Project No. R.026175.001

January 21, 2016

**The following changes to the tender documents are effective immediately and will form part of the contract documents:**

PROJECT TITLE  
 NORTH DISTRICT BUILDING  
 RECAPITALIZATION

Figure #1 Fume Hood to be removed and reconnected-Refer to Phase II – Main Floor Demo.

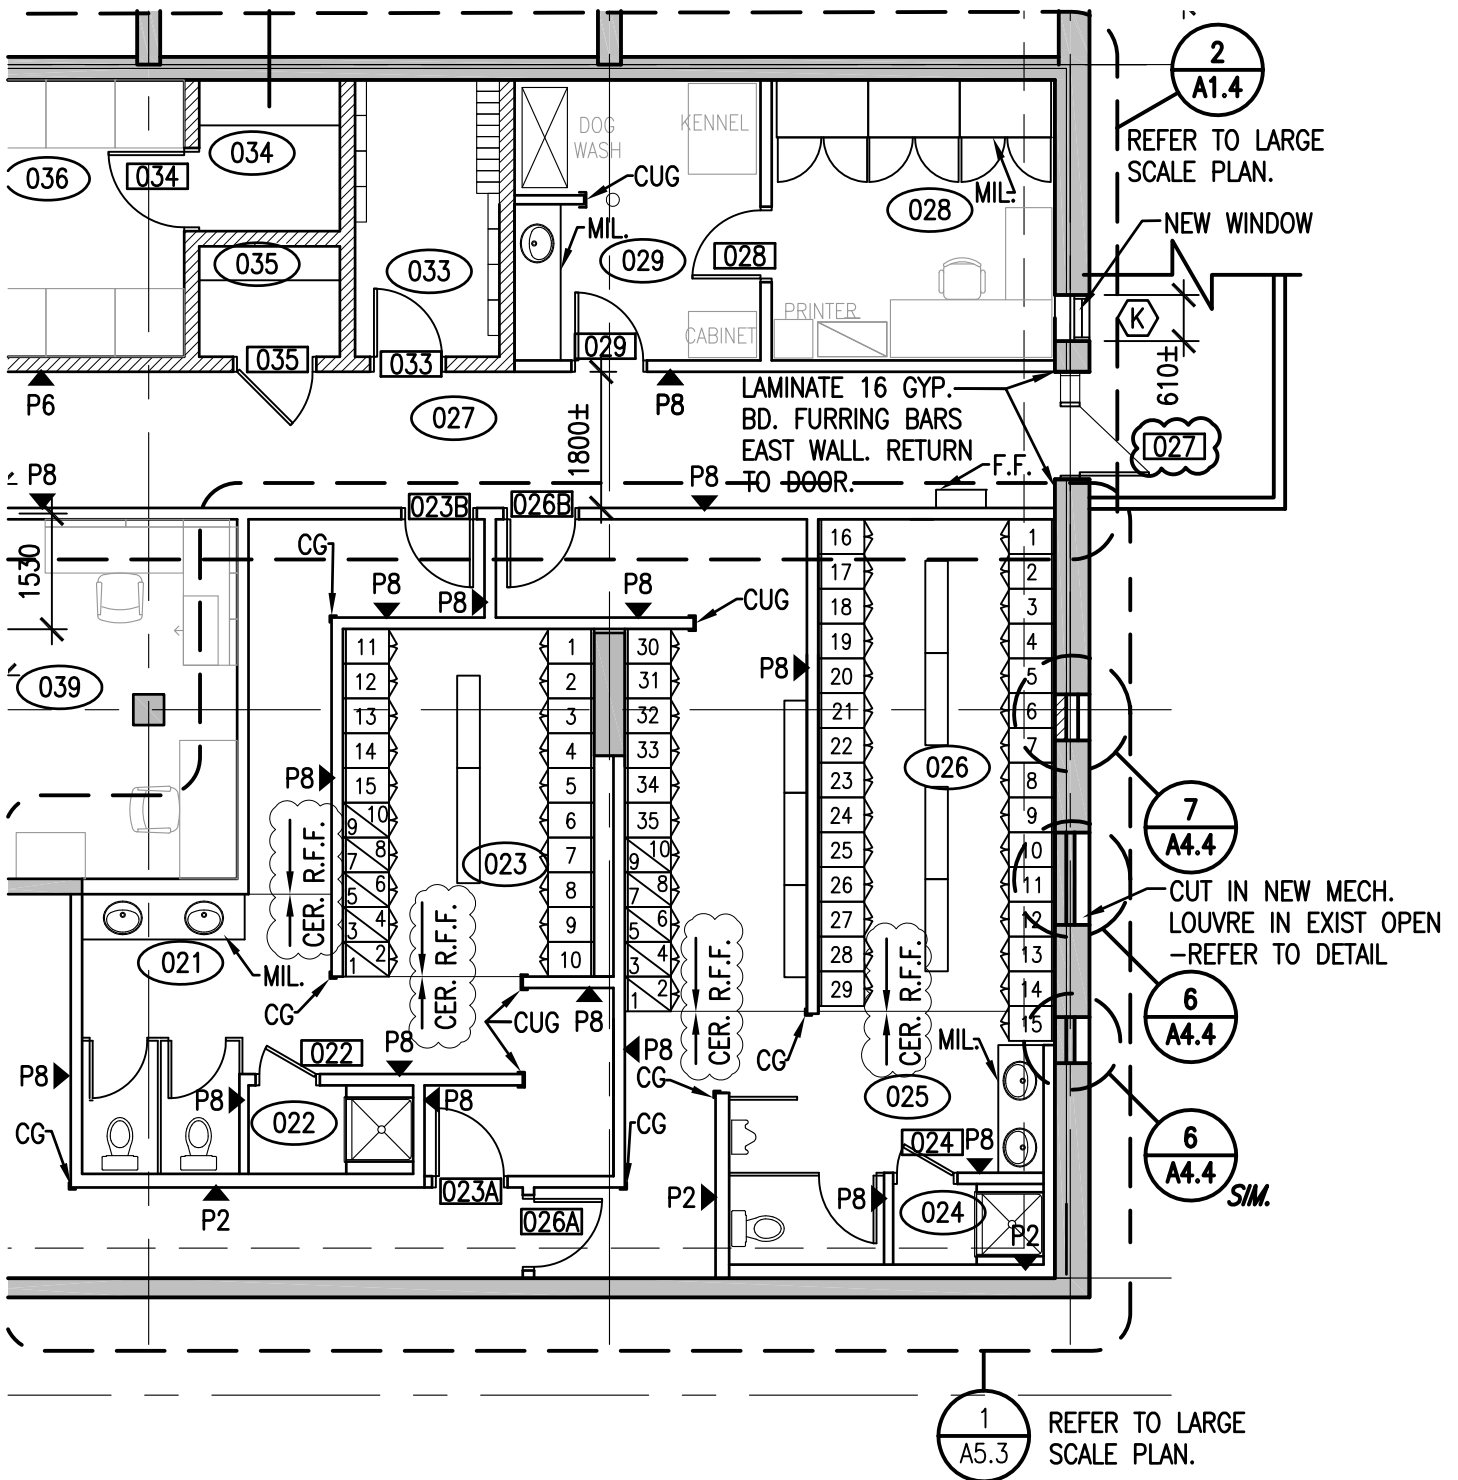
- .1 Detail 2: Revise note on two pieces of equipment below grid E and 6-7 to read: "Disconnect existing Fume hood and CA Chamber and move into temporary storage in Lower Level. Move back into renovated space at complete of new work. Refer also to mechanical/Electrical for disconnecting/connection of services." Refer also to Figures #1 & #2 on page 9 of this addendum.
- .2 Detail 2: Revise note on owners' equipment above grid D and 6-7 to read: "Contractor to move existing owner equipment into lower level storage and return after completion of work. Coordinate with owner."

- .1 In the room along Gridline 6/D the contractor shall disconnect all equipment in this room and package all disconnects and associated switches and receptacles with each piece of equipment for re-installation in the new Room 111. Two pieces of equipment shown along the south west wall are being re-installed in the new space.

- .1 In Room 111 the contractor shall re-connect the relocated equipment shown along the west wall. Utilize existing electrical disconnects packaged with salvaged equipment from the demolition phase.

**AR2.1**

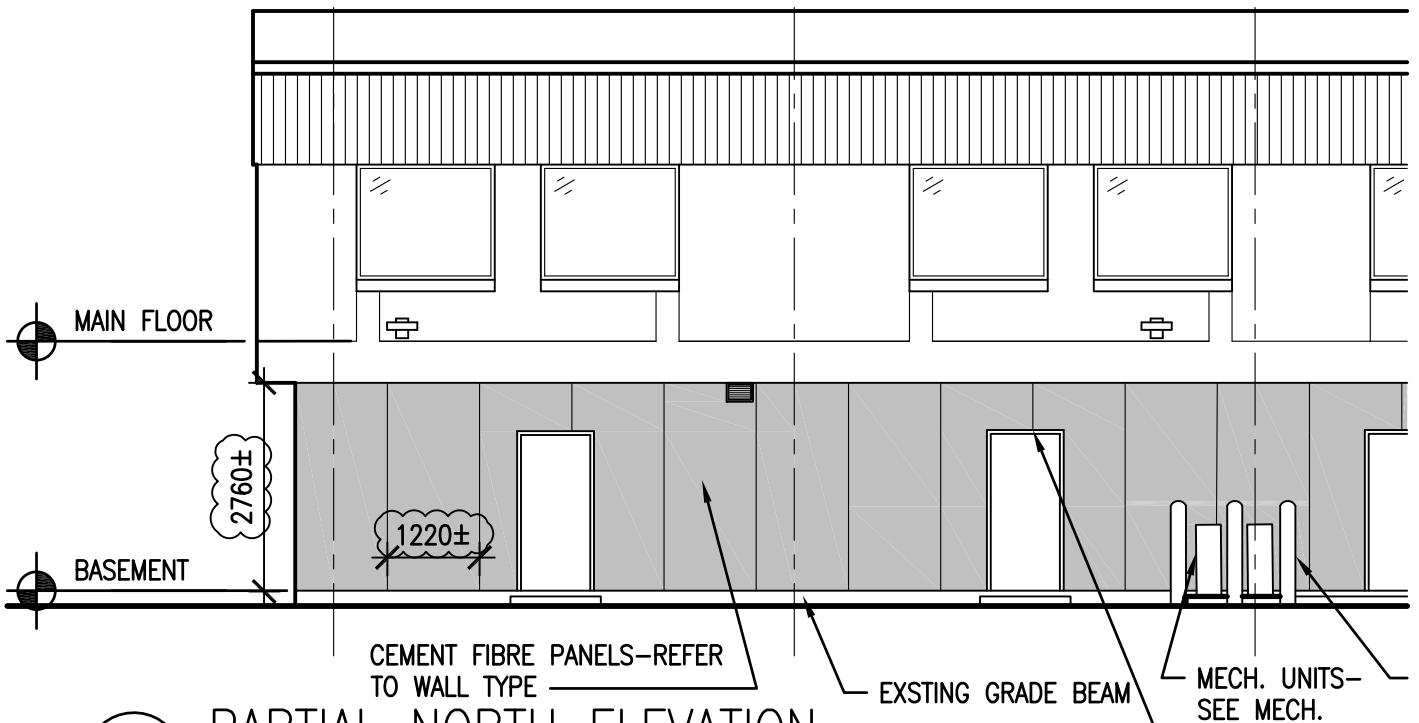
- .1 Reference detail 1: Refer to attached drawing for extent of flooring / transitions in rooms 021-026 as shown on drawing AR2.1, attached to this addendum.

PROJECT TITLE NORTH DISTRICT BUILDING RECAPITALIZATION	DATE 2016-01-15	PROJECT NO. R.026175.001
	SCALE SHOWN	DRAWING NO.
DRAWING TITLE EXTERIOR SIDING CLARIFICATIONS	DRAWN CT	<b>AR2.2</b>
	CHECKED RP

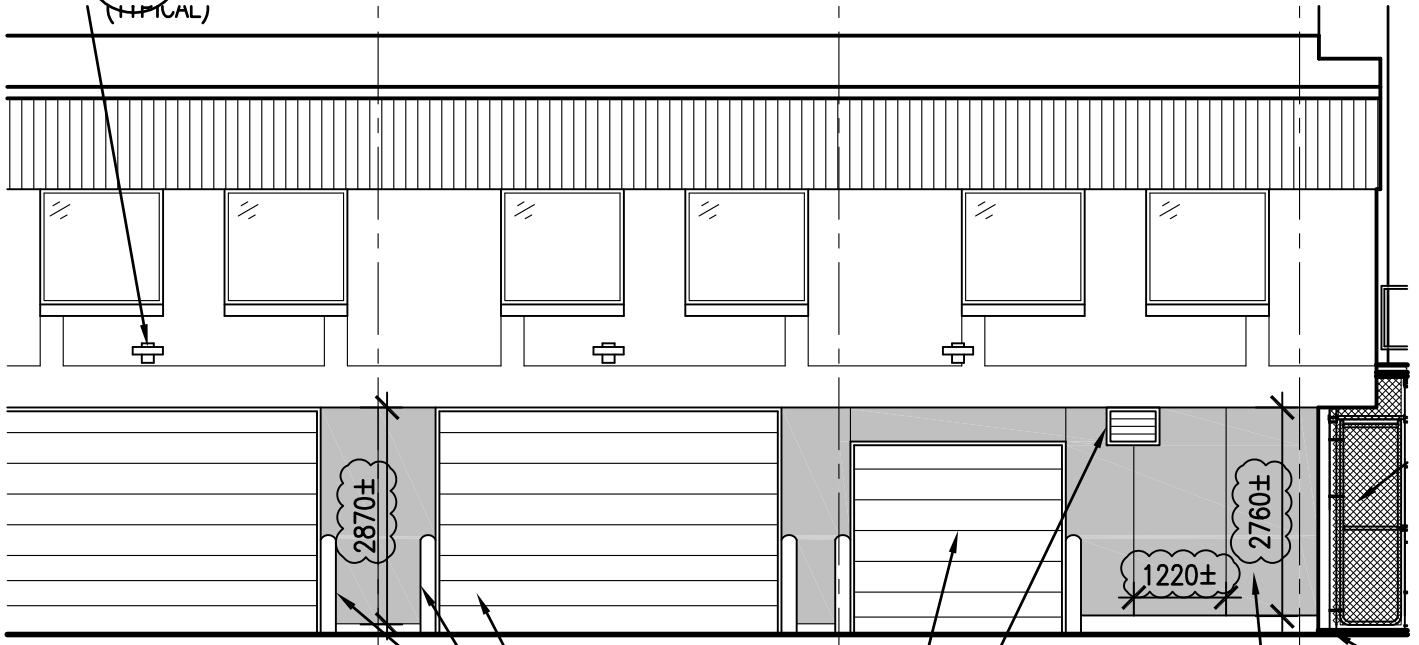
2.2.1.3 Revise to read: “Length: 2426mm or 3025mm – refer to attached AR2.2 for sizes.”

- .1 Revise detail 2/A3.1 as shown on Drawings AR2.2 to show approximate Cement Siding panel sizes, attached to this addendum.
